UNITED STATES PATENT AND TRADEMARK OFFICE

APPLICATION NO.	FILING DATE	FIRST NAMED INVENTOR	ATTORNEY DOCKET NO.	CONFIRMATION NO.
10/674,906	09/30/2003	Jason MacNeal	AVX-236	9002
22827	7590	03/18/2005	EXAMINER	
DORITY & MANNING, P.A. POST OFFICE BOX 1449 GREENVILLE, SC 29602-1449			THOMAS, ERIC W	
			ART UNIT	PAPER NUMBER
			2831

Office Action Summary

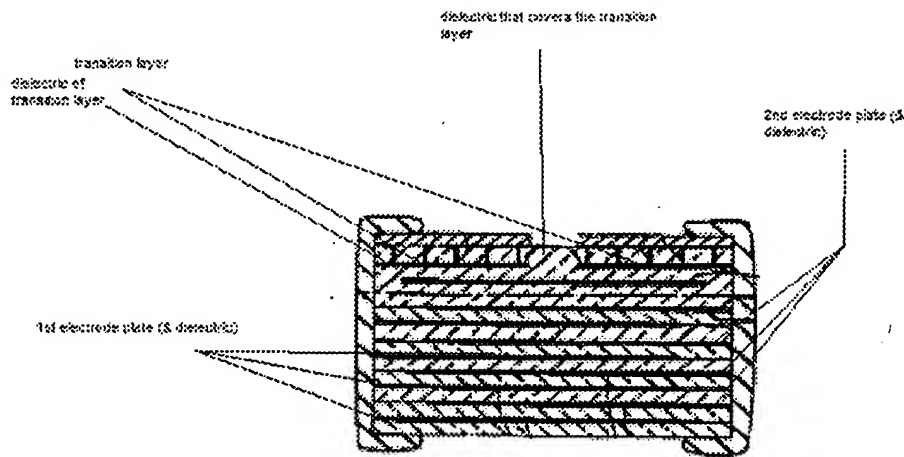
Devoe et al. disclose in fig. 9A, a multilayer electronic device, comprising: a plurality of dielectric layers; a plurality of electrode layers (10,11) interleaved with selected of said plurality of dielectric layers to form a multilayered arrangement, wherein each said electrode layer (10, 11) extends to and is exposed along at least one side surface of the multilayered arrangement; said multilayered arrangement defined by first

and second opposing surfaces and a plurality of side surfaces; at least one respective first (68) and second (66) transition layer electrode portion provided on the first surface of said multilayered arrangement; a cover layer (lower most ceramic layer) provided over said at least one respective first and second transition layer electrode portion, said cover layer formed to define a plurality of openings there through for exposing a portion of said at least one respective first and second transition layer electrode portions; at least one first peripheral termination formed along selected side surfaces of the multilayered arrangement and electrically connecting selected of said electrode layers and said at least one first transition layer electrode portion; and at least one second peripheral termination formed along selected side surfaces of the multilayered arrangement and electrically connecting selected of said electrode layers and said at least one second transition layer electrode portion.

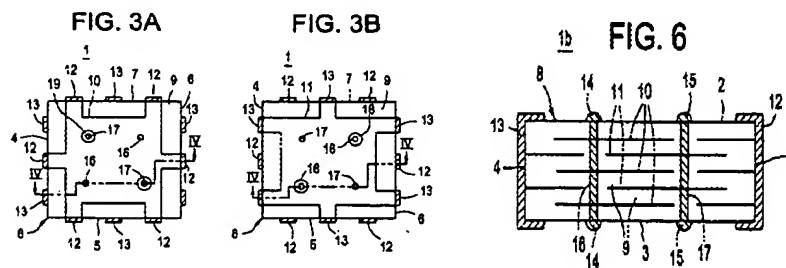
Kuroda et al. disclose in fig. 3A, 3B, 4, 9, a multilayer capacitor, comprising: a plurality of dielectric layers (9); respective pluralities of first (10) and second (11) electrode layers interleaved with selected of said plurality of dielectric layers to form a multilayered assembly, said multilayered assembly defined by topmost and bottommost layers and a plurality of adjacent side surfaces; at least one first via termination (16) provided through the topmost layer of said multilayered assembly and **electrically connected** to an electrode tab of one of said first electrode layers; at least one second (17) via termination provided through the topmost layer of said multilayered assembly and **electrically connected** to an electrode tab of one of said second electrode layers; at least one first peripheral termination (13) provided along selected side surfaces of said multilayered assembly and electrically connecting said plurality of first electrode layers; and at least one second peripheral termination (12) provided along selected side surfaces of said multilayered assembly and electrically connecting said plurality second electrode layers.

Regarding claim 16, Kuroda et al. disclose each of said plurality of first electrode layers respectively includes a plurality of electrode tabs extending to and exposed along selected side surfaces of said multilayered assembly, wherein said at least one first peripheral termination electrically connects selected electrode tabs from the plurality of first electrode layers, and wherein said at least one second peripheral termination electrically connects selected electrode tabs from the plurality of second electrode layers.

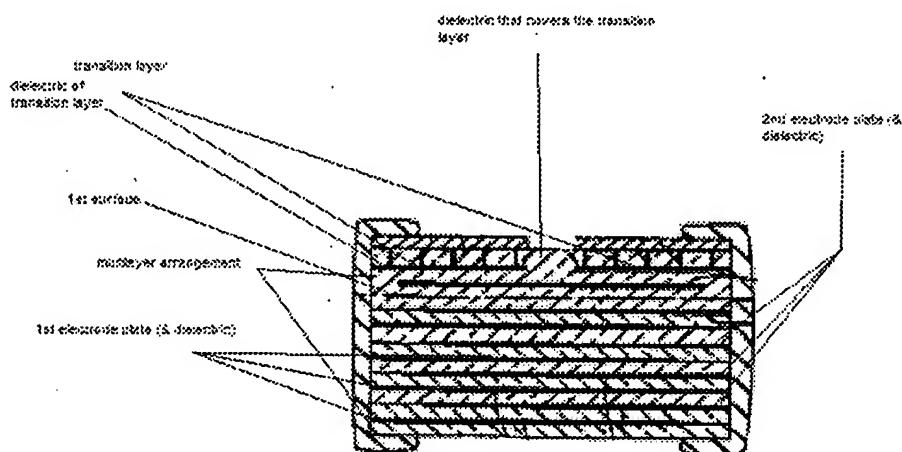
B) (Devoe et al. do not disclose providing first and second transition layer electrode portions on the first surface of the multilayered arrangement) The examiner does not agree (see illustration below). The transition layer is formed on the first surface of the multilayered arrangement.

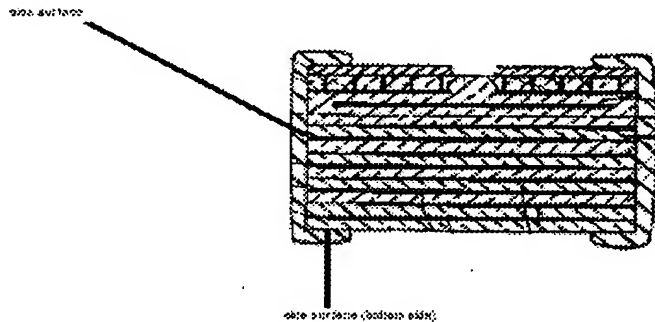
surface of the multilayer device and wrap around to at least one side surface adjacent to the respective selected side surfaces. The examiner does not agree. Devoe et al. disclose the peripheral terminations extend along the entire left/right sides and wraps around the bottom side surfaces (see fig. below).
